**Pacific Gas and Electric Company's (PG&E's)  
2014 Energy Storage Request for Offers ("RFO")  
Frequently Asked Questions  
(updated 02-11-2015)**

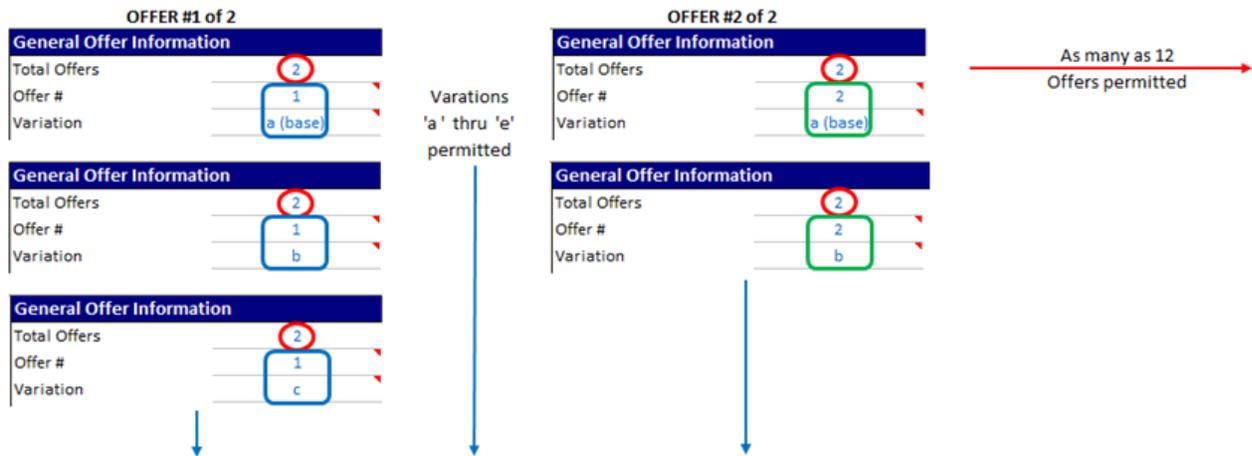
- Can you clarify the difference between offers and variations, and how to number/letter them? (added 02-11-2015)
  - You may submit up to twelve (12) Offers. Changes in a Project’s location, technology, or specific agreement type (e.g., ESA, or PSA) would result in a new Offer. You may submit up to five (5) variations. If a Project’s location, technology, or specific agreement type remain constant, then changes in other characteristics such as delivery term, price, commercial operation date, capacity, or duration would constitute a unique variation.

- Example:** Offer Form screenshots for two Offers are illustrated below. The first Offer (PSA) has 3 variations, a → c. The second Offer (ESA) has two variations, a → b. In the illustration below there would be five (5) Offer Form workbooks submitted, for the five (5) unique variations. Each Offer should submit a complete Offer package of applicable appendices. PSA packages should not include ESA information and vice versa.
